Subject: Amendment No. 7 to Facility Operating License No. NPF-13 -
Grand Gulf Nuclear Station, Unit 1

MISSISSIPPI POWER AND LIGHT COMPANY
MIDDLE SOUTH ENERGY, INC.
SOUTH MISSISSIPPI ELECTRIC POWER ASSOCIATION
DOCKET NO. 50-416
GRAND GULF NUCLEAR STATION, UNIT 1
AMENDMENT TO FACILITY OPERATING LICENSE

License No. NPF-13
 Amendment No. 7

STAFF EVALUATION
 AMENDMENT NO. 7 TO NPF-13
 GRAND GULF NUCLEAR STATION, UNIT 1
 DOCKET NO. 50-416

Bases Figure B 3/4 3-1
REACTOR VESSEL WATER LEVEL

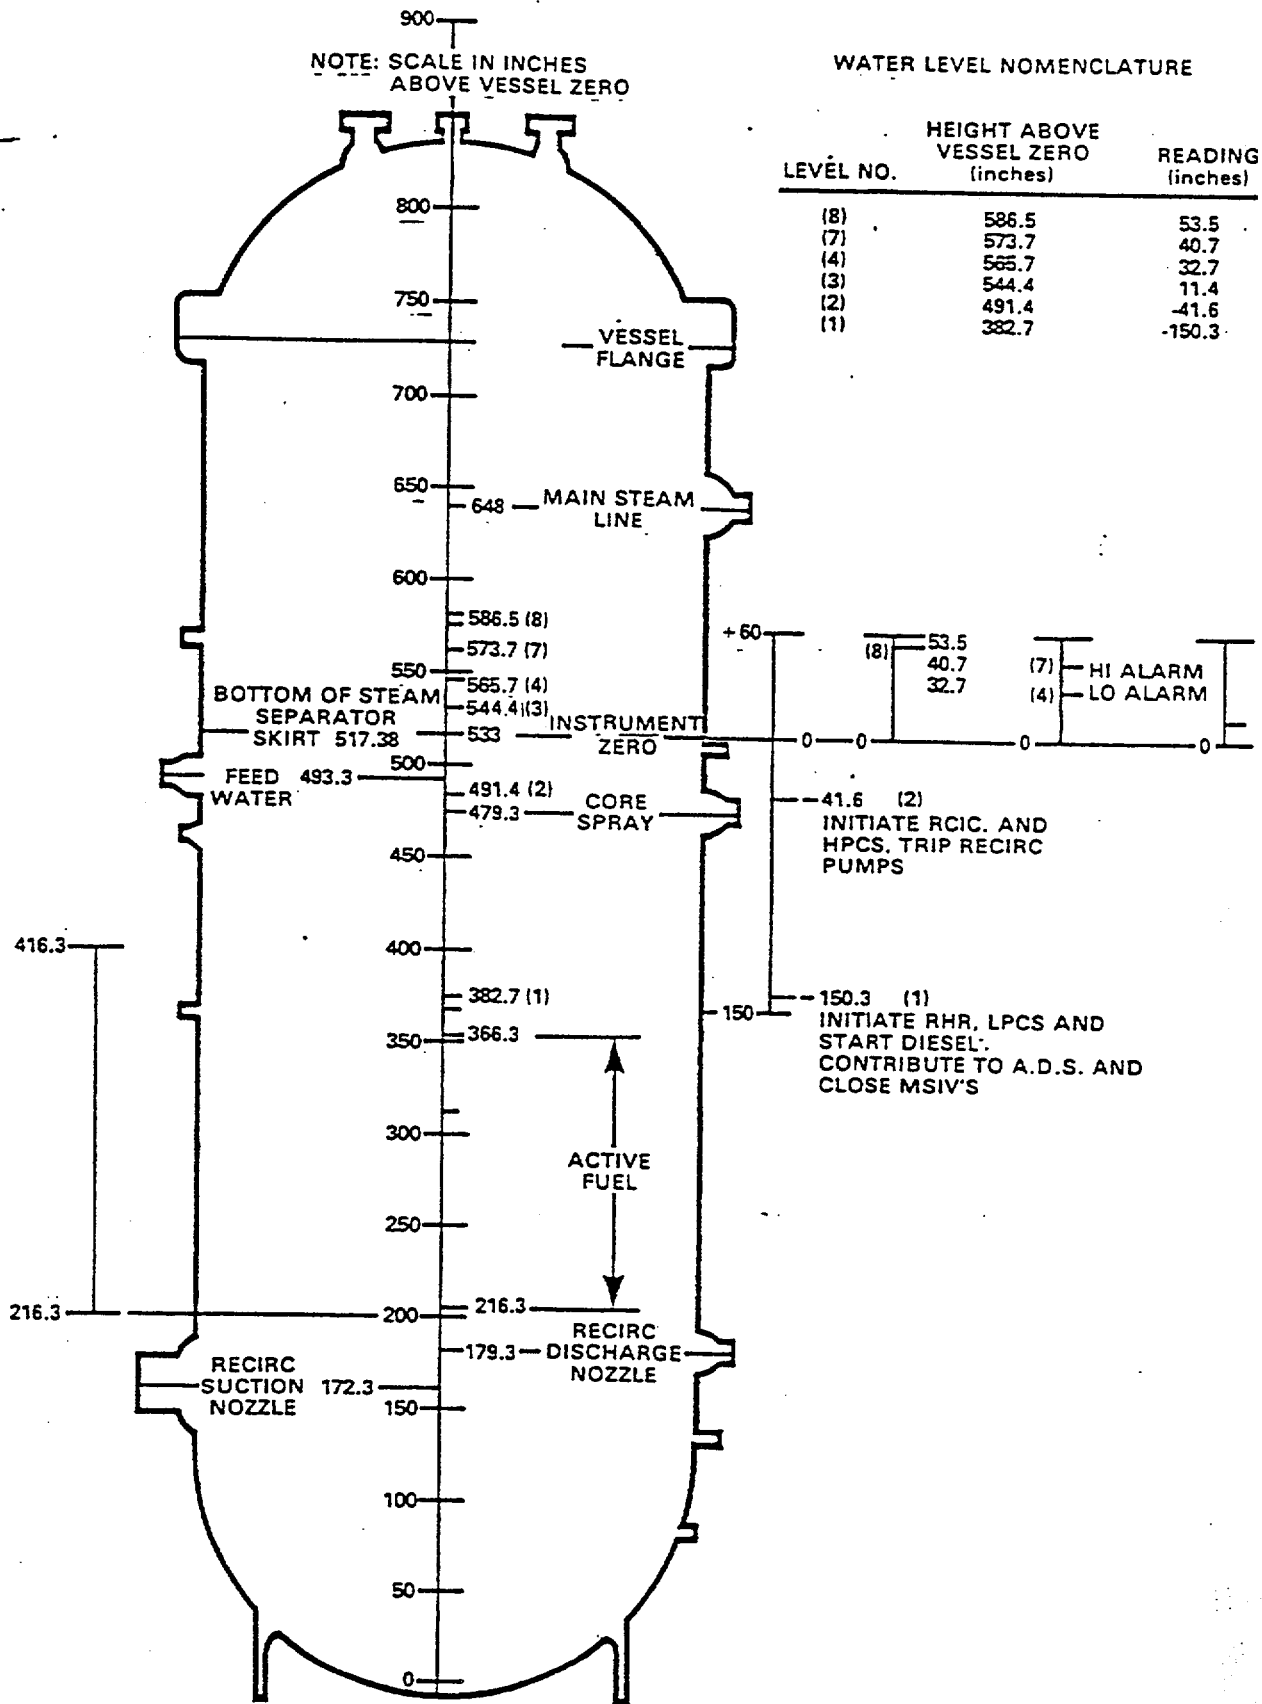
Letter Reference	Item	BASES Section
3/24/83	3	B 3.0.3
3/24/83	4	B Figure 3/4 3-1
3/24/83	8	B 7.2
